Comparison of an Ultrasonic Phased Array Evaluation with Destructive Analysis of a Documented Leak Path in a Nozzle Removed from Service

AD Cinson, SL Crawford, PJ MacFarlan, BD Hanson, and RA Mathews
Pacific Northwest National Laboratory¹, Richland, WA, USA

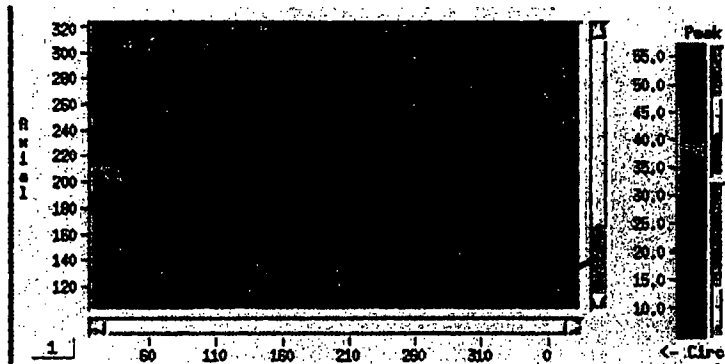
Comment [P0011]: Confirm you have permission to use this figure and make publically available.
